DATE: January 4, 2024
TO: Planning Commission Members
FROM: Tom Schauer, Senior Planner
SUBJECT: Additional Information for Record - Dunn Place PDA 1-23, S 1-23, TML 5-23

This memo provides additional information for the January 4, 2024 public hearing for Dockets PDA 1-23, S 1-23, and TML 5-23 for Dunn Place. This includes written public testimony received by the Planning Department after the December 28, 2023 meeting material packet.

SITE PLAN

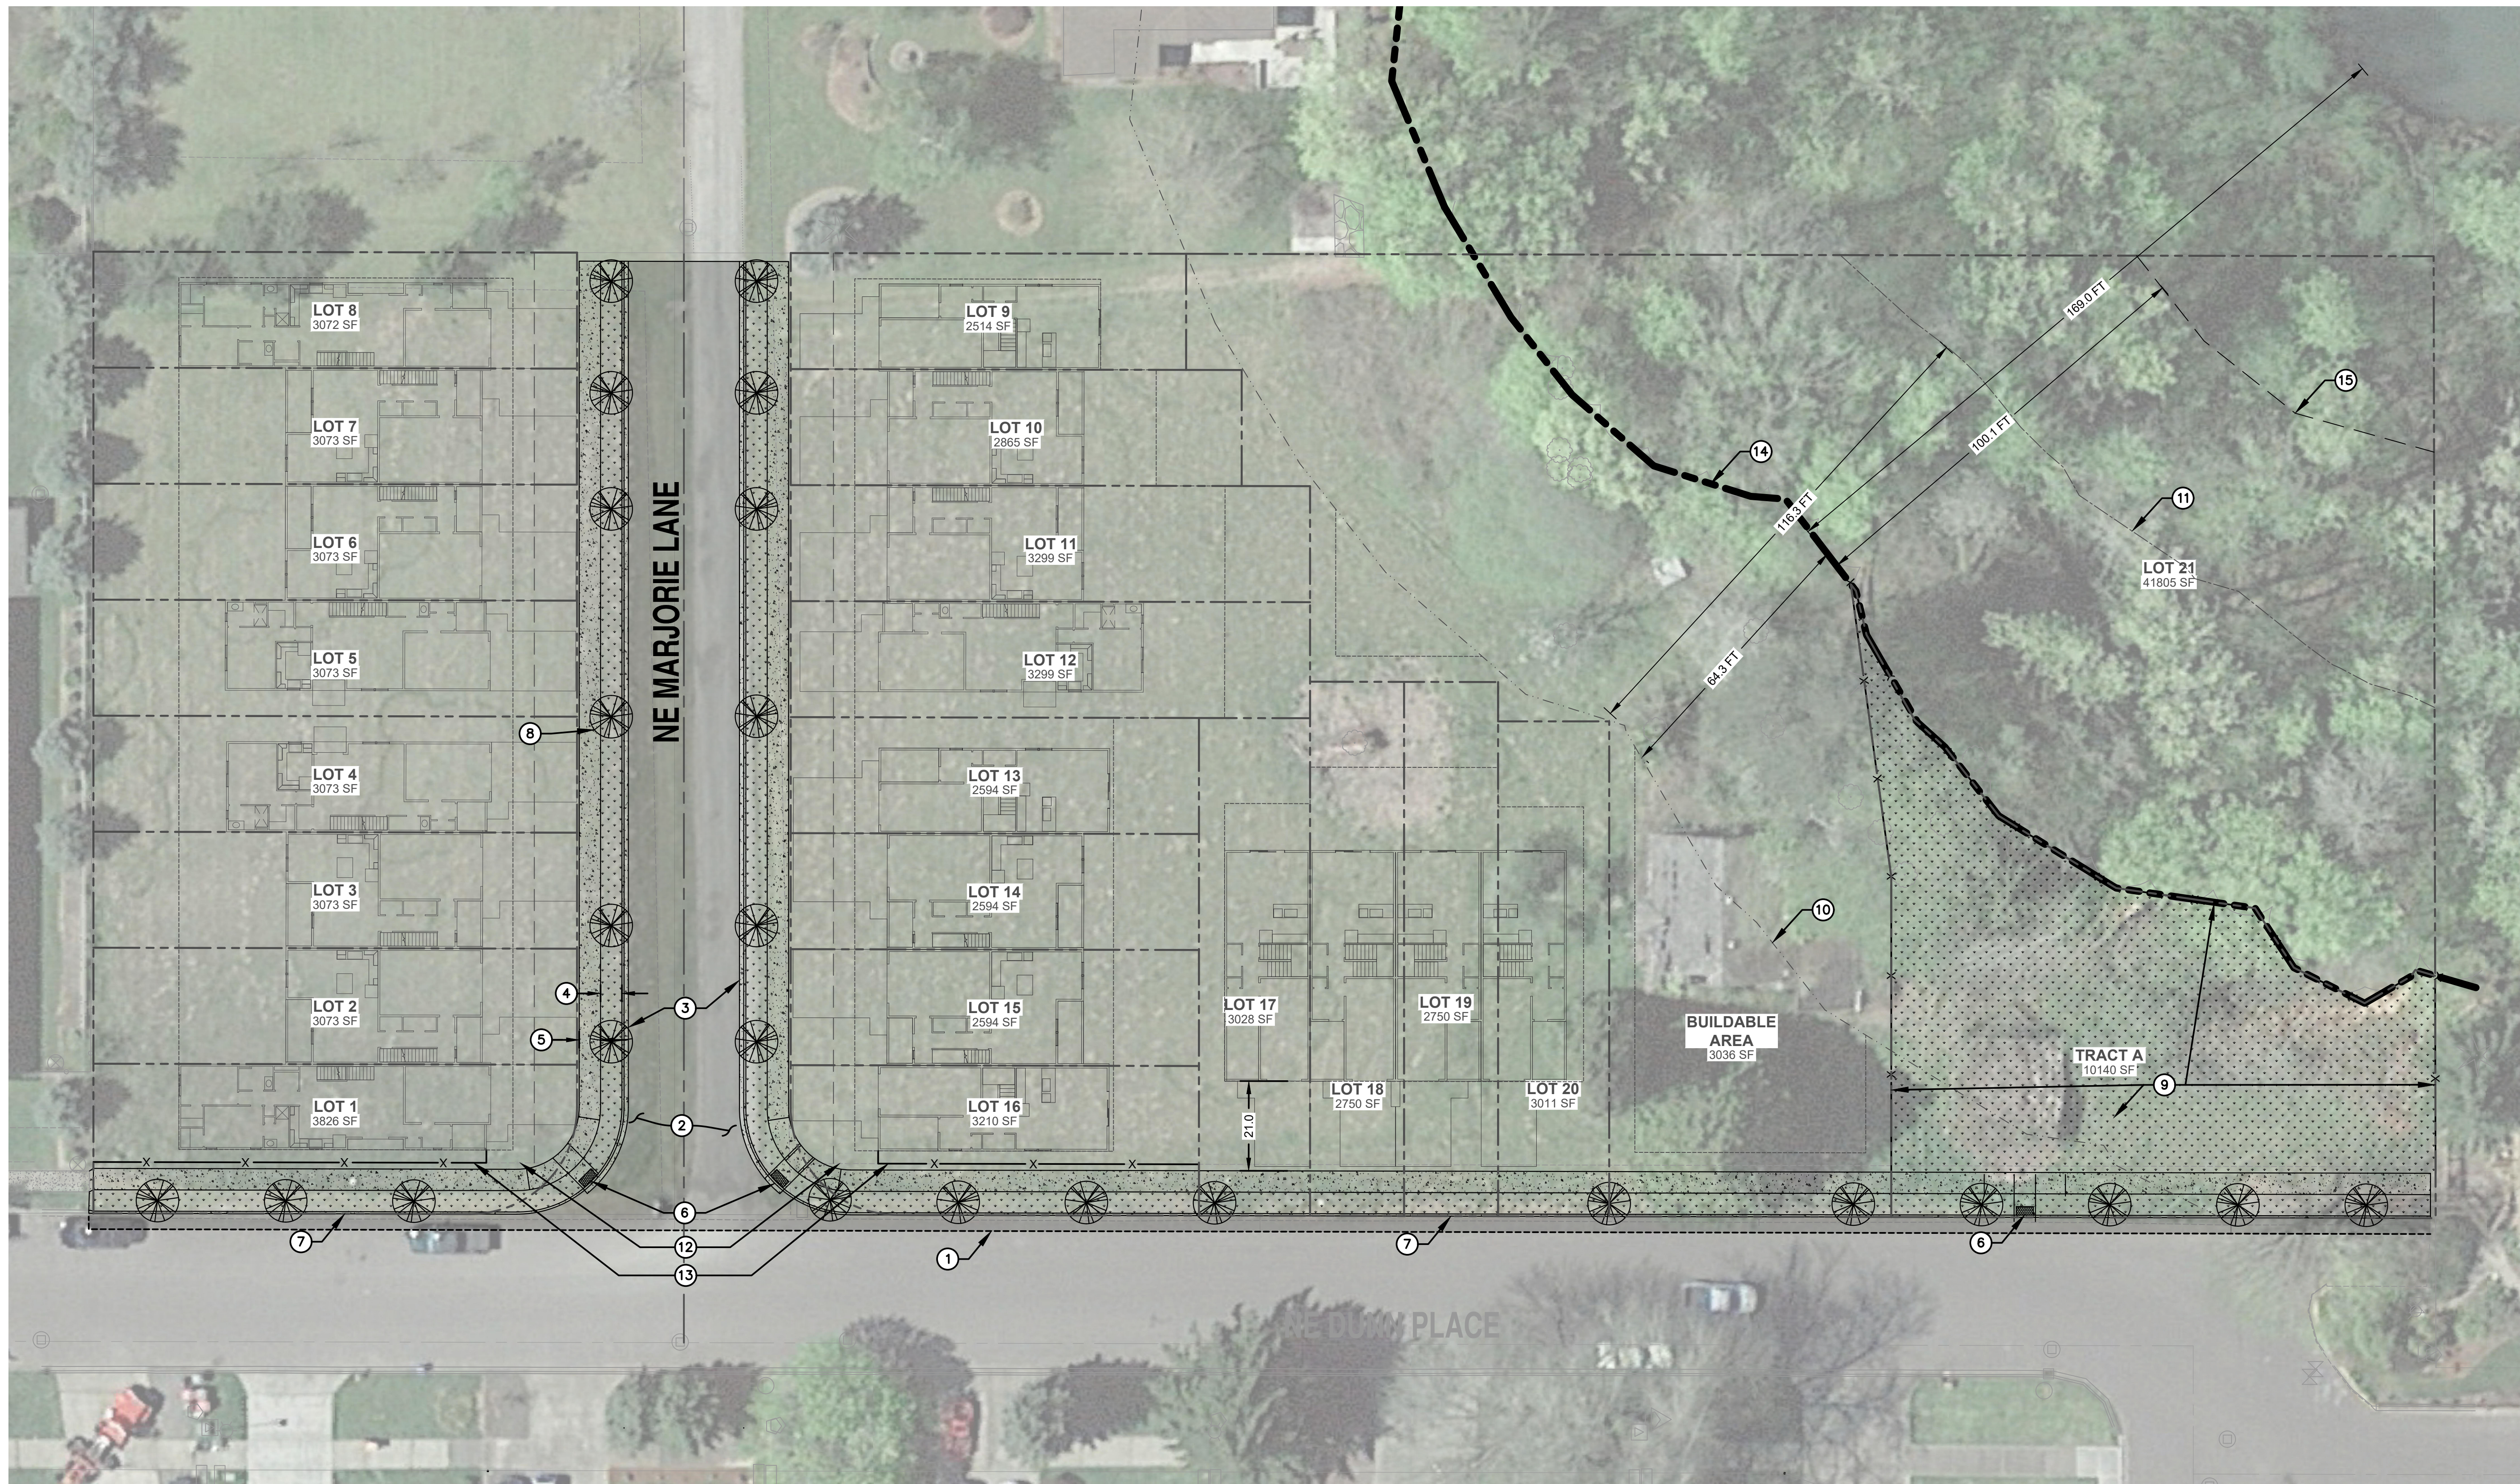
The staff report include a new/revised condition #10 that the lot lines of the three of the townhouse lots be adjusted so they are not within the 60-foot setback from top of bank described in the geotechnical report and shown on the plans. The applicant submitted revised plan sheets on January 3, 2024 showing revised lots that would comply with that condition. *Attachment 1.*

South Yamhill River in McMinnville Oversite of Areas Affected by Mass Wastage

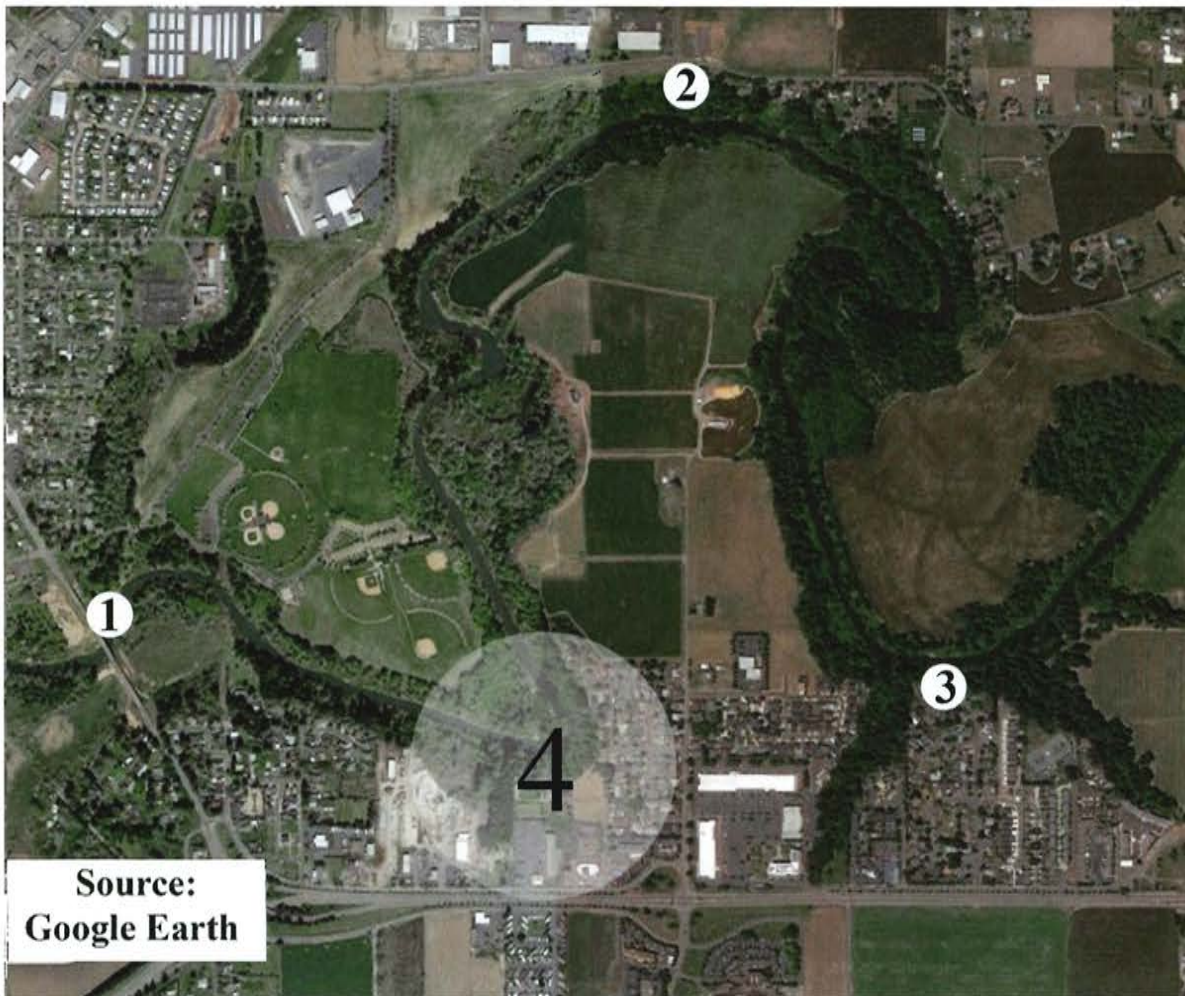
**An interesting study of perspectives:
My terrace denotes the top of the bank for
my property; the fuzzy line marks the
“approximate line of the top of the bank”
that the developer chooses to use.**

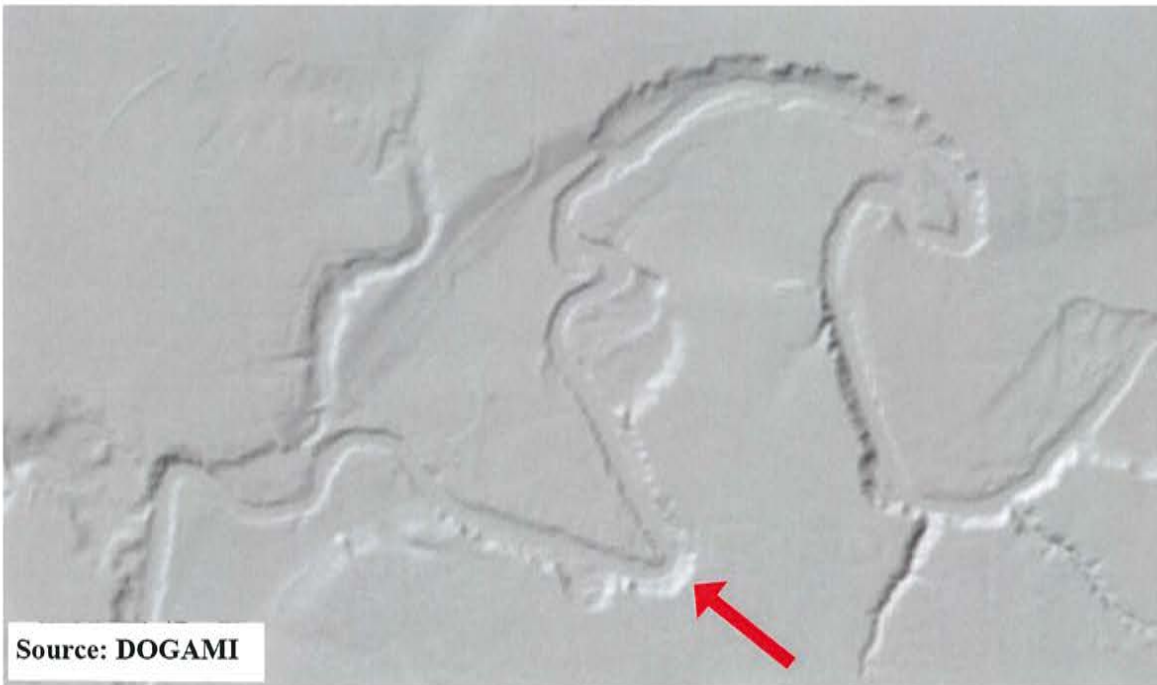
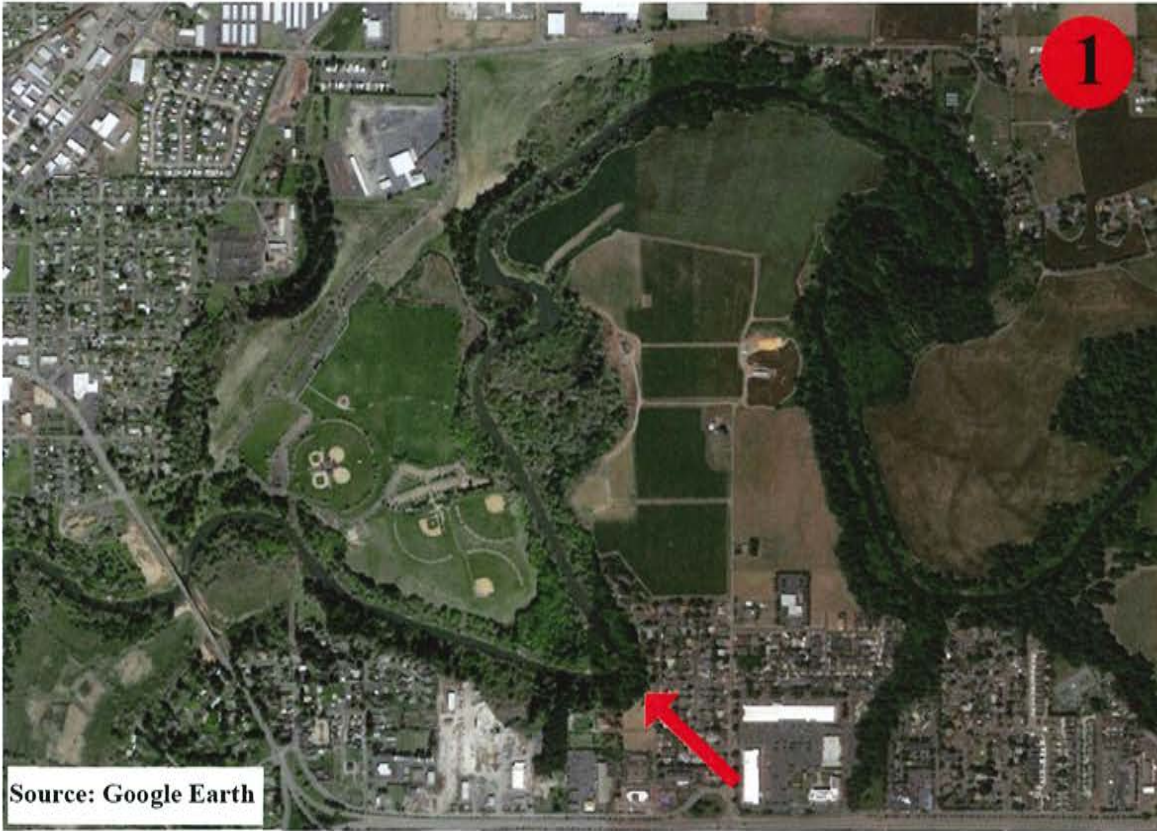
1. The proposed development sits at the very apex of an extremely sharp bend of the river, making it much more at risk to mass wasting than a straight river course, something that is not taken account of in the geo-tech reports. (See 1)
2. Water (and erosional processes) follow the course of least resistance. Evidence of a year round seep, spring, or drainage is apparent in the form of bullrushes and wet ground all the

way to the top of the bank, well above the levels indicated in the Geotech reports. (See 2)

3. A mass wasting event at the industrial site is progressing slowly, and a similar event at the proposed location would encompass the whole of the development and parts of neighboring properties and Dunn Place itself. (See 3)
4. Continuous bank slumps scar the river bank of the Cal-Portland cement site as well as adjacent downstream properties, including Chalmers Court, 165, 235, 265 and 301 NE Dunn Place. This is clear evidence of ongoing bank erosion which the Geotech reports do not recognize. The old city dump, repeatedly brought to the attention of the City of McMinnville Engineering and Planning Departments and each time promptly forgotten, underlays Chalmers Court, 301, 265 and probably intrusive onto 235 Dunn Place. Without first determining the extent of the dump, the planned addition could have devastating effects. (See 4.1, 4.2, 4.3, 4.4, 4.5, 4.6)

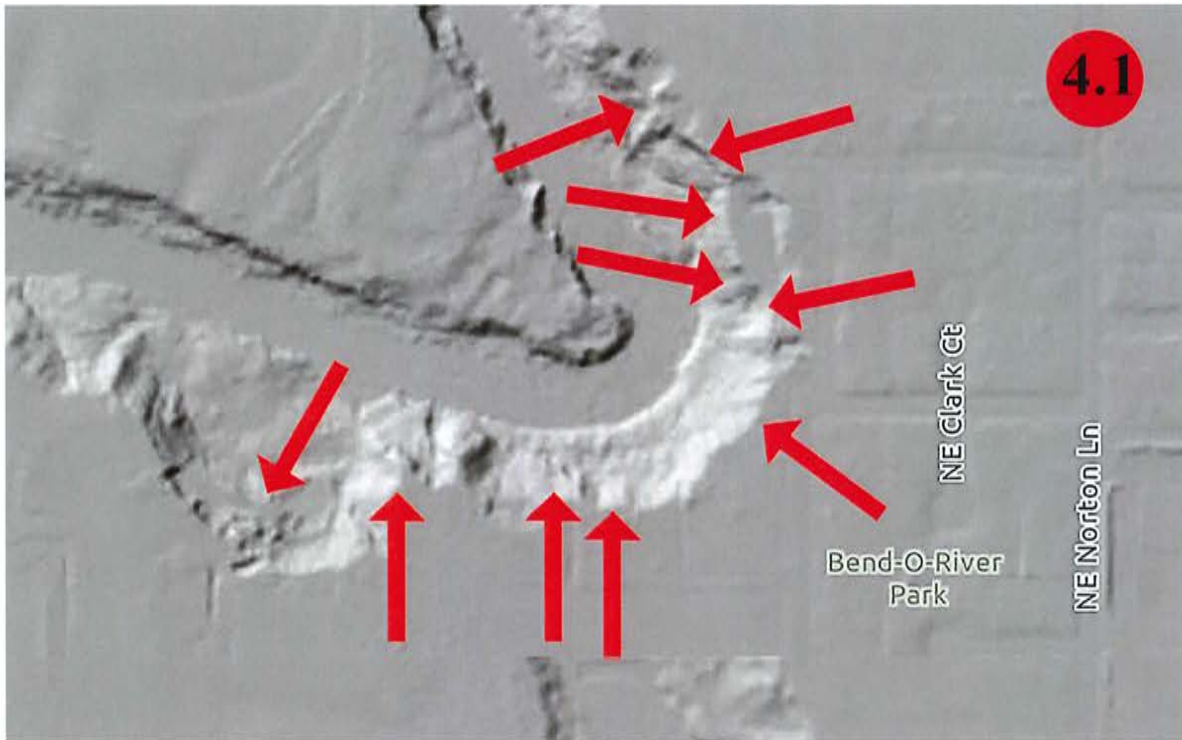
A mass wasting block just upstream from the proposed development (highlighted below) borders a concrete plant.

Red arrows indicate bank collapses, slumps and failures that have happened just in my lifetime. Blue shading shows area of greatly increased bank scour occurring because of the acute river bend.

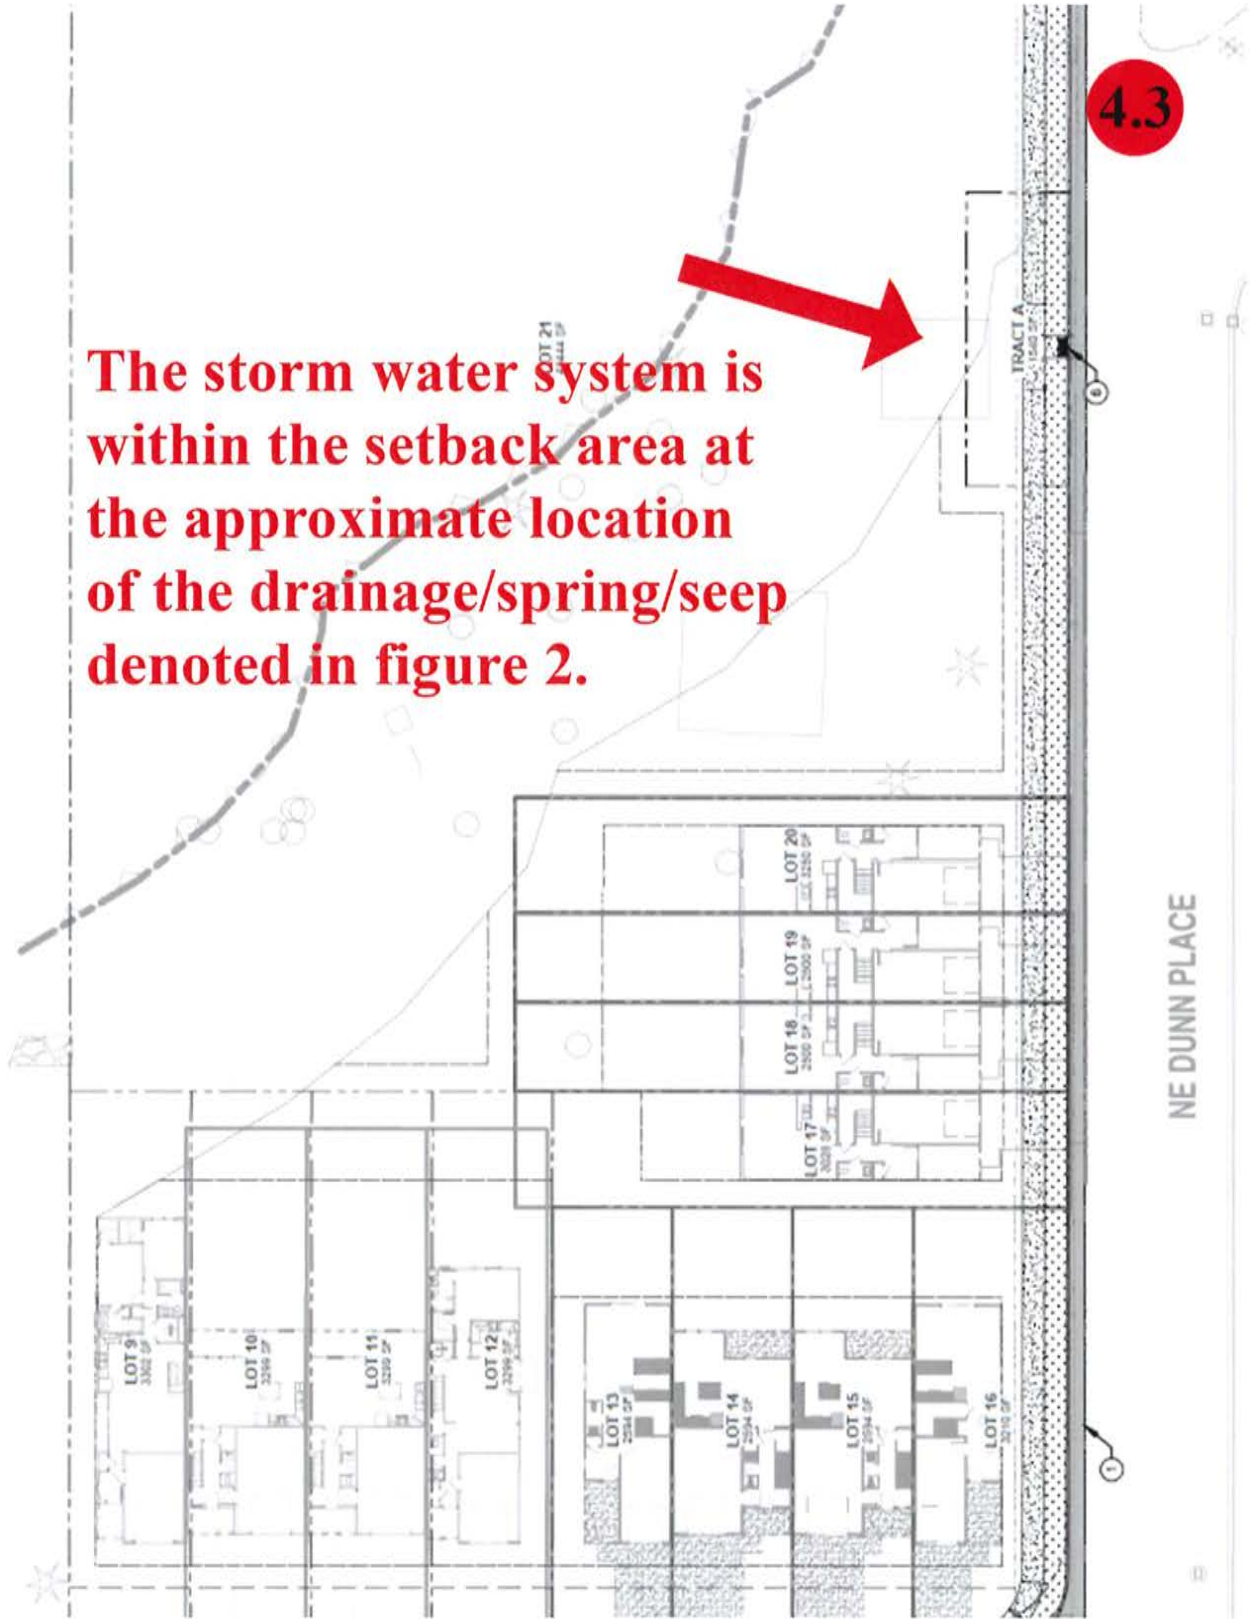
This is the effect of a flood event and heavy rainfall occur at the same time on a very acute bend of the river. None of the data submitted by the developer consider the cumulative effect of these factors: that is not the purpose of a geotech report, but rather of a geologist with knowledge and experiance in the forces of mass wasting.

The storm water system is within the setback area at the approximate location of the drainage/spring/seep denoted in figure 2.
